RE: Proposed New Mixed-Use Building
Auburn Development Review Application
186 Main Street
Tax Map/Lot: 231/020

### **AUBURN SITE PLAN REVIEW - SUPPLEMENTAL INFORMATION - A**

Project: 186 Main Street, Auburn, Maine

Comments Received from City Staff Review: 2023-05-12

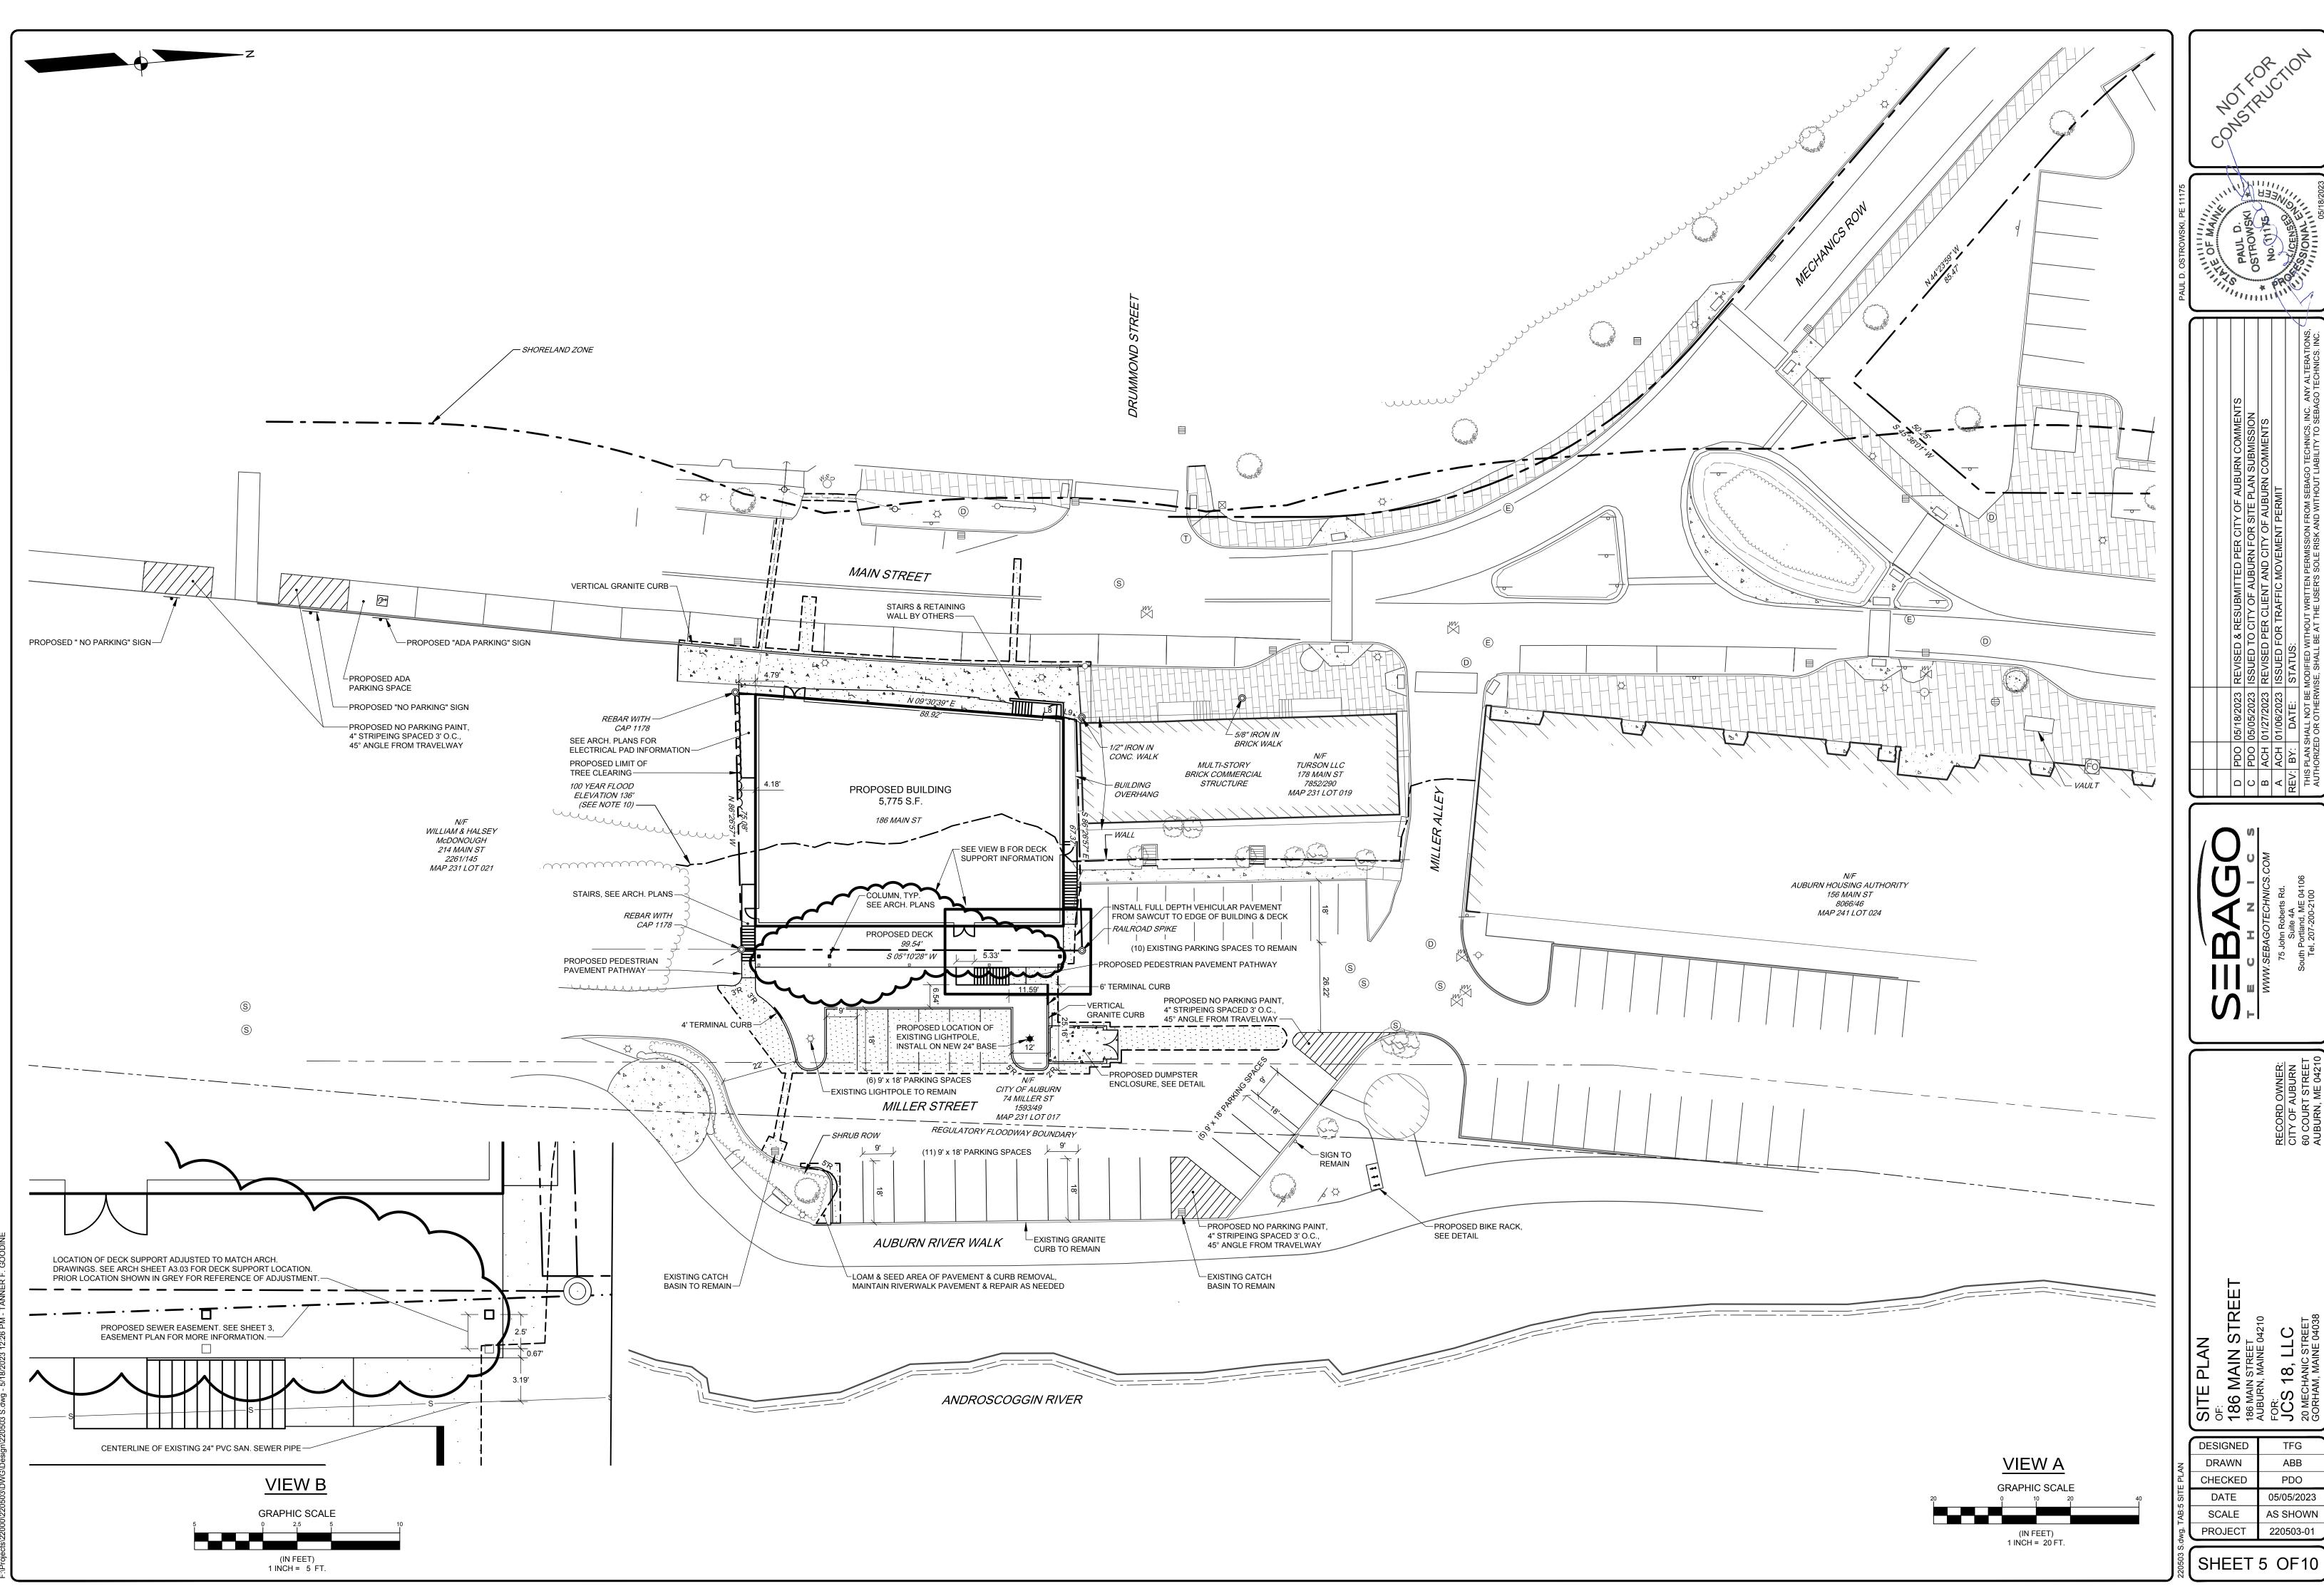
4. The City of Auburn requested additional narrative and information on the deck support system and how this is concerning the existing 24" sewer pipe directly east of the deck.

Additional information has been provided to outline the design of the deck support system concerning the existing 24" sewer pipe. Please see Attachments 3,4, & 5 for additional information on the design of the deck support system.

The following information is intended to describe the best practice methods being utilized at and around the existing sewer pipe running along the rear of the building. The rear deck projects from the face of the main buildings foundation system extending 3'-0" past Column line 4.3 in a cantilevered condition. Based upon the survey work completed, this will provide a little more than 5'-0" between the centerline of the column line 4.3 and the center line of the understood pipe location. The pipe is 24" in size, therefore providing 4'-0" clear from face to pipe to center line of column. The column is expected to set upon a 24" square footing. A smaller concrete pier will be placed atop the footer to extend upwards to 6" above the grade line for the wood posts to set upon. This cantilevered condition was intentionally put in place to eliminate any weight distribution being placed upon the pipe itself which is the primary intent.

The stair assembly at the edge of the deck is also a wood framed structure setting upon a floating slab. It is intended to be free standing and bolt fasted to the face of the deck allowing disassembly and removal if ever needed at a later point in time. This also was intentional. The slab will distribute the small load of the stair over a grater area and the overall removability will aid in accessing the pipe in the future should excavation needs arise.

The current design is based upon the best information we have at this point in time. As construction starts and the earthwork initiates, it will be the intent to uncover the pipe and establish its exact location. This will allow us to adjust the deck size or the location of 4.3 line as needed to assure that the deck loads are not transferred to the pipe.
